GROUP Body	MODEL 2014MY Forte (YD)
	NUMBER PS396	DATE April 2015

SUBJECT: WATER LEAKING INTO TRUNK AND/OR REAR FLOORBOARD AREA

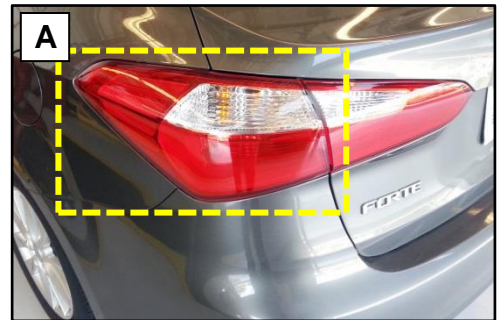
On some 2014MY Forte (YD) vehicles, produced prior to May 21, 2014, customers may complain of water leaking into the trunk and/or rear floorboard area, after a rainstorm or a carwash. This condition may be caused by improper sealing between the outer tail lamp (A) gasket and the body of the vehicle. To resolve this concern, replace the existing gaskets with the improved parts on both outer tail lamp assemblies. **NOTE: Do NOT order the complete outer tail lamp assembly to resolve this concern.**

NOTE: The improved gasket for the outer tail lamps is made from a different, darker-colored material and is 1mm thicker than the original part (B).
